**Town of Crested Butte
Board of Zoning and Architectural Review
December 18, 2018**

*Consideration of the application of **Michael R. Haney** to demolish/relocate the existing primary residence and construct a new primary residence and make additions to the existing accessory building located at 20 Third Street, Block 3, West 100 feet of Lots 20-21 and West 100 feet of the South half of Lot 19 in the R1 zone.*

1 Site
1" = 10'-0"

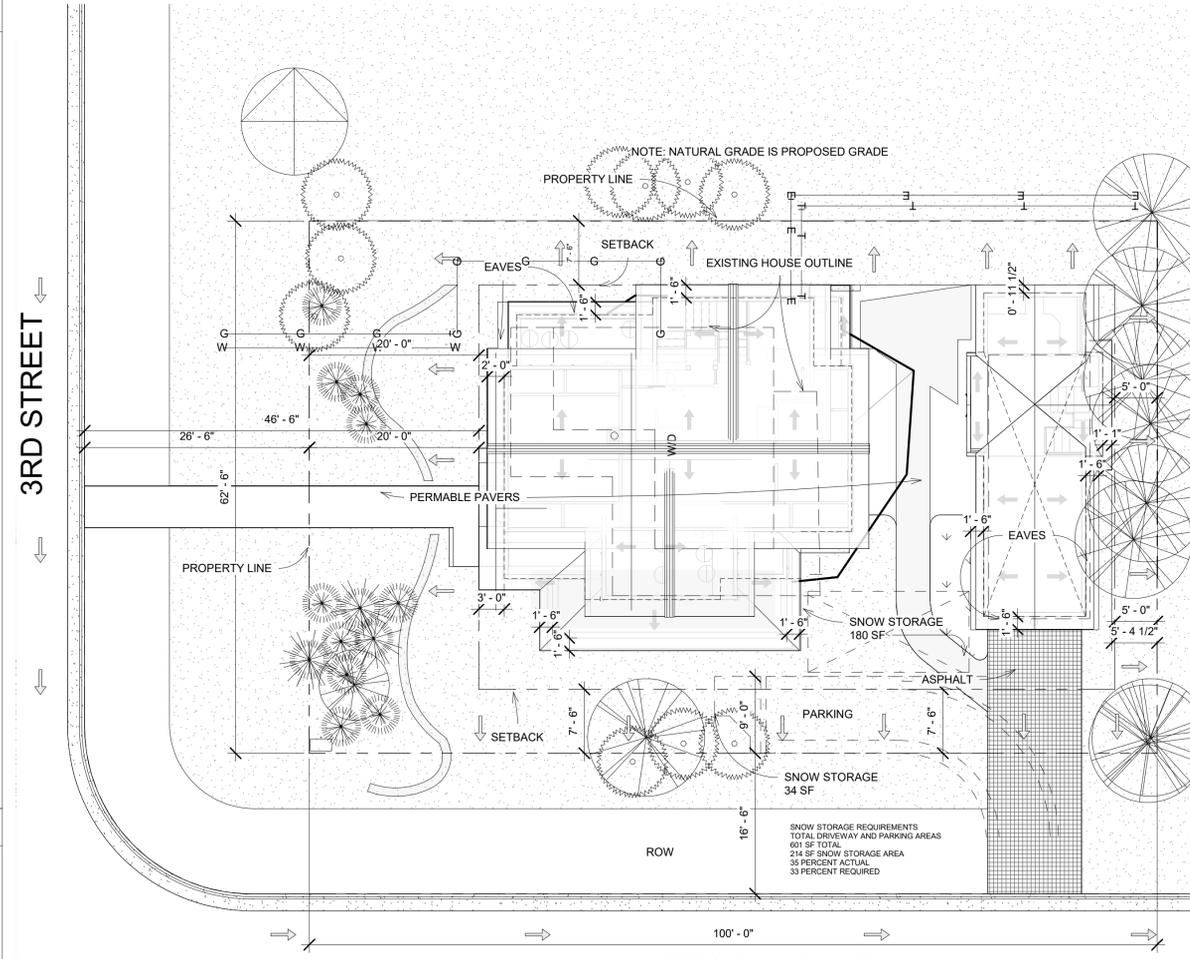
- Topography and drainage: *Topographical information must be provided. The Town's GIS documentations notes 2' variation in elevation on the site.*
- Drainage has been added to the plan and flows to the South and West.

- Snow storage areas are noted on the plan.
- Setbacks-
 - Primary:
 - Front yard: 20'
 - North side yard: 7'6"
 - South side yard: 11'
 - Distance between buildings: 14'

Site planning: Refer to guidelines 4.24 – 4.28, 2.32-33. The plan is well developed that incorporates existing trees, walkways, parking surfaces and ground cover. The plan depicts retention of mature landscaping. Discussion of whether the contractor will have to remove or relocate a section of trees for access for excavation access. The Board is encouraged to discuss the location of the parallel parking space per GL 4.26 (a) relating to 20’ of street frontage for parking when alley access is not feasible. The lighting plan appears well developed and consistent with the Town lighting code. DRC was supportive of the proposed parking and site plan as a whole.

Site plan – They spoke about if the home came out, which direction would be best. The foundation will come out and a partial basement will go in for mechanical. The rest would be a 32” crawlspace. A portion of the porch was removed to comply with FAR requirements. This was the South and East elevation.

Drainage – Barney explained on the site plan to the south and to the west.

Parking – Ellis said it wasn't clear on the plan. Barney said it is parallel to Teocalli, which was the same on this summer's plan. They overviewed how this will function. Parallel spaces have been approved, but generally on the alley. There was support for this space in this location.

Utilities – Minneman asked for those to be added to the plans. It was believed to be on the adjacent property. There might be an easement for this. Gas would need to be rerouted and the meter would most likely go on the North.

② GARAGE NORTH
1/4" = 1'-0"

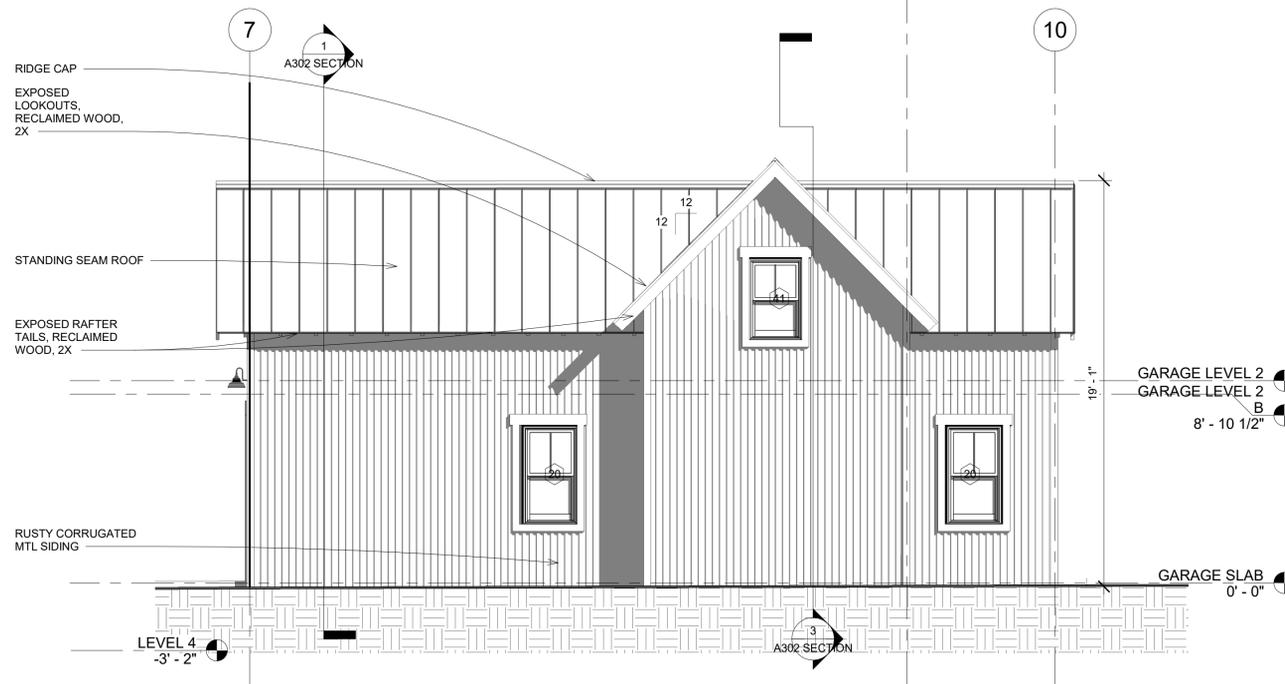
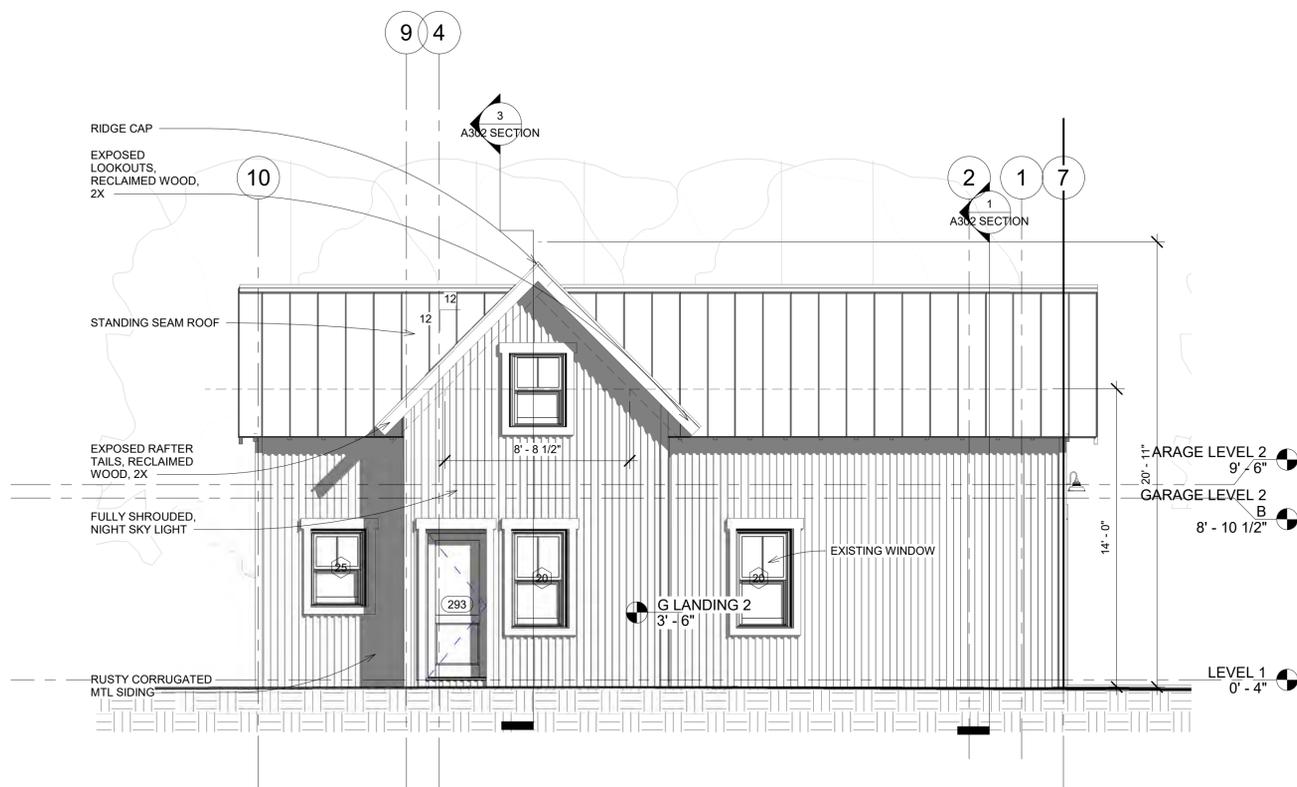
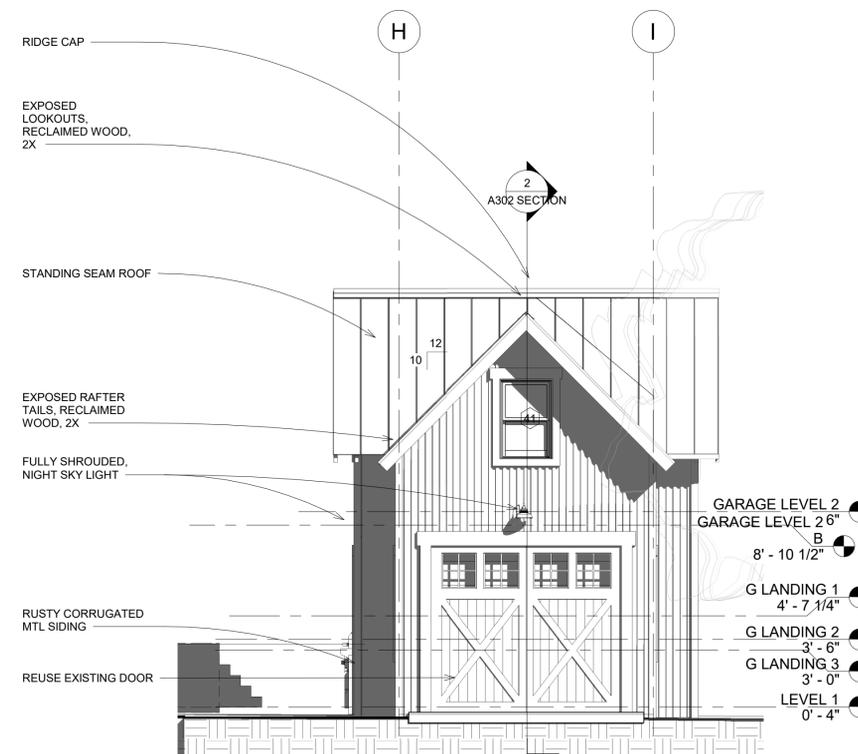
Accessory Building: Refer to Guidelines 4.79-4.83. The existing building will be altered, raising the height from 18'10" to 20', and the length is increased from 34'6" to 38', and wall additions to the east and west elevations. The focus is to add area for a gear room on the first floor and art studio on the second floor. The north/south gables have been lowered slightly to help conform to FAR requirements. Members discussed the cruciform shape and length and said that they have approved similar complexity in other locations. Also, vegetation and landscaping will help to shield this from Teocalli Avenue.

The Board will have to determine whether the overall mass and scale will appear consistent with the intents of GL 4.82, and accessory buildings within the neighborhood. The scale of the 38' long roof ridge in plan form may appear dissimilar. Visiting the site, if you haven't already, will enable Board members to discern whether the scale will appear inconsistent or be hidden from view. The forms incorporates two gable walls. The guideline encourages be of simple design and massing. The roofing to be standing seam roof with Zactique finish. Consider conventional corrugated metal material. DRC appreciated the consistency of the roofing material for this and the primary home.

Accessory – Ellis asked about the mix of materials. Barney said that they were going to leave the metal that is there, but he could change to all corrugated. Russell said that GL ask for one siding type on AB's. So, they supported all metal.

They supported the change of materials to one (metal).
